CZECH SPORT AIRCRAFT	<h2 style="margin: 0;">SAFETY ALERT / SAFETY DIRECTIVE</h2>	Czech Sport Aircraft a.s. Na Záhonech 212 686 04 Kunovice Czech Republic office@czechsportaircraft.com
No. SA-SC-007		Rev.: -
Date: 2017-11-29		
Page: 1 of 9		Date: -

MODEL AFFECTED:	SportCruiser
SUBJECT:	Inspection and / or replacement of the valve push-rod-assy. for ROTAX® Engine Type 912 S2 and 912 ULS2.
AIRCRAFT AFFECTED:	<ol style="list-style-type: none"> 1. Aircraft serial numbers C0552, C0555, C0556, C0576, C0577, C0578, C0579, C0580, C0581, C0582, C0583, C0584, C0585, C0586, C0587, C0588, C0591, C0592, C0593, C0594, C0595, C0596, C0597, C0598, C0599, C0600, C0608, C0609, C0610, C0611, C0612, C0613, C0614, C0615 2. All other aircraft the engine of which has been equipped with valve push-rod assy. part no.854861 during the engine repair, maintenance or general overhaul within the period as of 01 May 2016 till 30 November 2017, inclusive. 3. All other aircraft with any of the following engine S/N installed:: <ul style="list-style-type: none"> - from S/N 6 772 119 up to S/N 6 772 185 inclusive - from S/N 9 580 001 up to S/N 9 580 262 inclusive - from S/N 6 785 892 up to S/N 6 786 198 inclusive - f

Fig.1 – Visual inspection

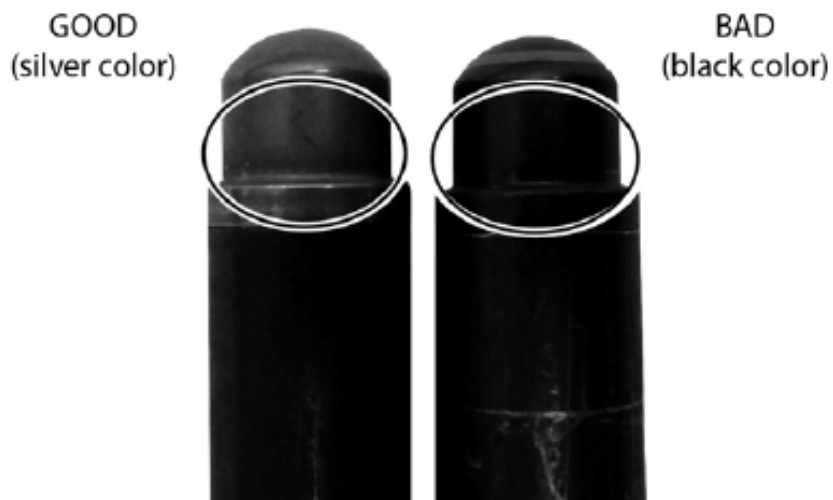
Perform visual inspection of all push-rod ball sockets on all cylinder.
Check for color. See Fig.1.

Color	Evaluation
Silver surface	Valve push-rod is OK. No further action required for this valve push-rod.
Black surface	Valve push-rod is NOT OK. See section. 13.6) Replacement of affected parts.

Fig.2

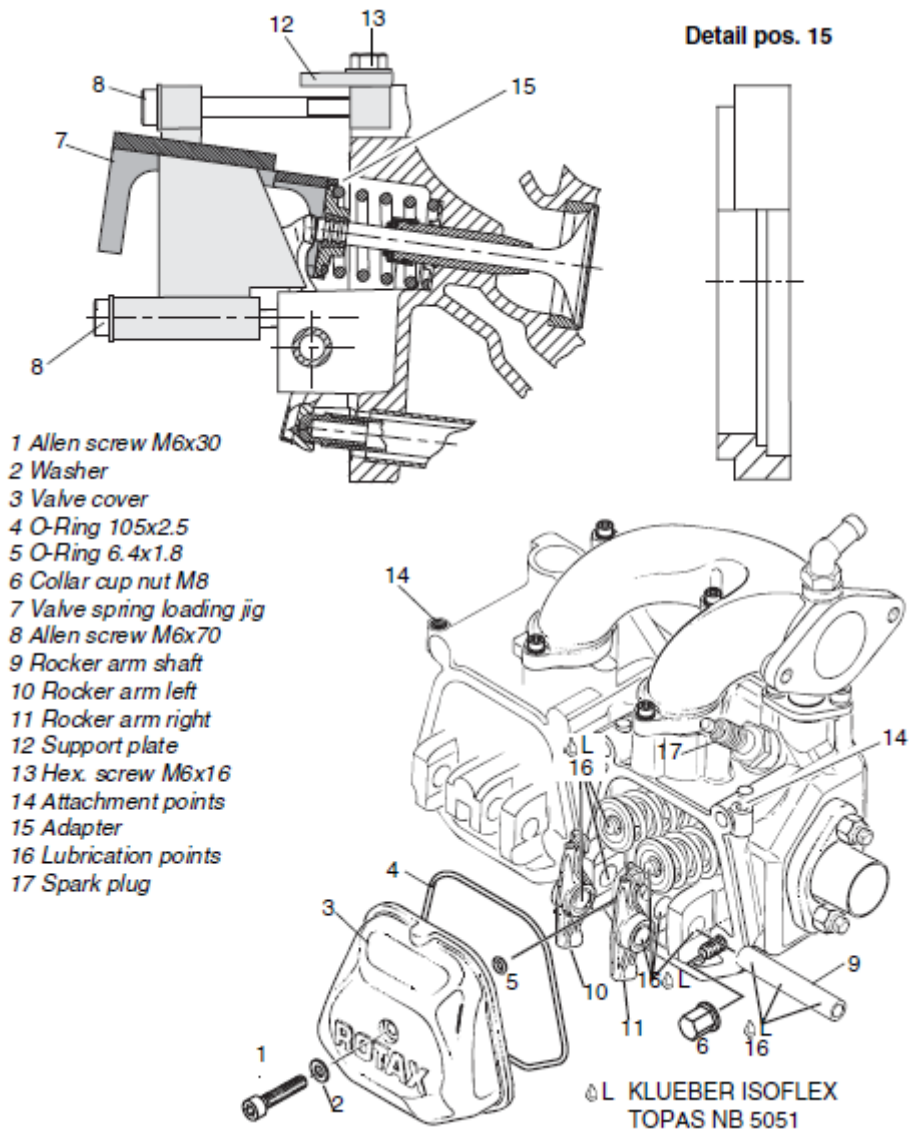
- 13.1 Move the aircraft to a suitable place to perform the work.
- 13.2 Remove the upper and bottom engine cowling, see the SC-AMM-1-0-00, the latest revision.
- 13.3 Disconnect the battery terminals.
- 13.4 Removing valve covers
See Fig.2.

Step	Procedure
1	Loosen Allen screw (1) M6x30 with washer (2) from valve cover (3), and remove it together with large and small O-rings (4) and (5).

See Fig.2.

Step	Procedure
1	Clean the sealing surface of cylinder head and valve cover with a suitable lint-free cloth or equivalent.
2	Insert new O-ring (4) 105x2.5 and O-ring (5) 6.4x1.8 into the valve cover (3).
3	Fit valve cover.

NOTE: Between the valve covers a gap of min.0,1 mm (.004 in.) must remain.
The covers must not touch each other.

Step	Procedure
4	Tighten the new Allen screw (1) M6x30 with washer (2) to 10 Nm (89 in.lb).

Fig. 3

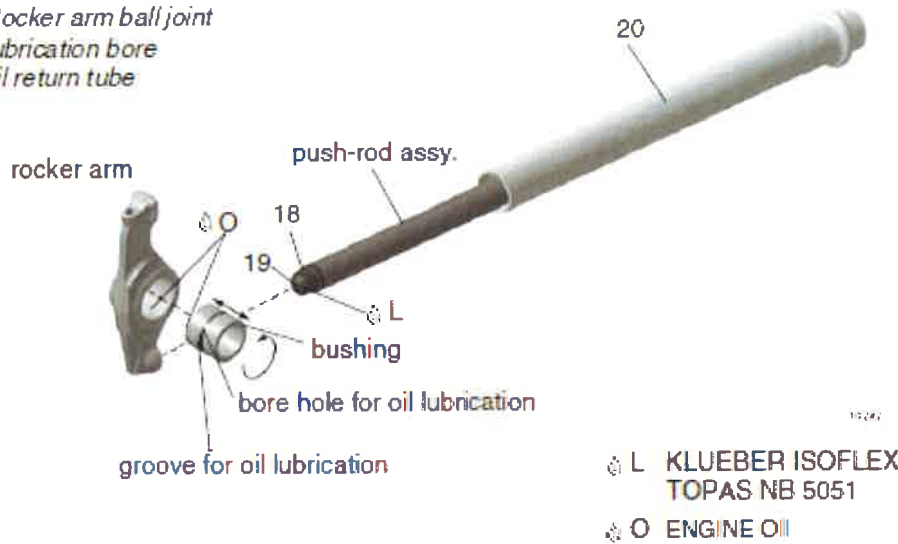
See Fig.2 and Fig.3.

Step	Procedure
6	This will relieve the pressure from both hydraulic tappets. Now the rocker arm shaft (9) may be easily pulled out. Lift out both rocker arms (10) and (11).
7	Replace only affected parts as per section 11.3). See also Fig. 3 .
8	Apply KLÜBER ISOFLEX TOPAS NB 5051 (16) on both push-rod ball sockets and contact areas of rocker arm and slide push-rod into the oil return tube (20).
9	Check bushing and rocker arm shaft according to latest Maintenance Manual Heavy.
10	Put oil on the rocker arm bushing.
11	Place rocker arm left (10) and rocker arm right (11) in cylinder head, apply KLÜBER ISOFLEX TOPAS NB 5051 (16) on rocker arm shaft (9) and insert it into its bearing support.
12	Loosen valve spring loading jig and support plate.
13	When removing the valve spring loading jig , make sure the adapter rings (15) do not jam on the valve spring retainer.
14	NOTE: Only when you have an Criterion B) Spare parts affected engine and only if engine is equipped with collar cap nuts M8 wrench size 13: Mount collar cap nut (6) according to latest Maintenance Manual Heavy or SI-912-025/SI-914-026/SI-912 i-010.
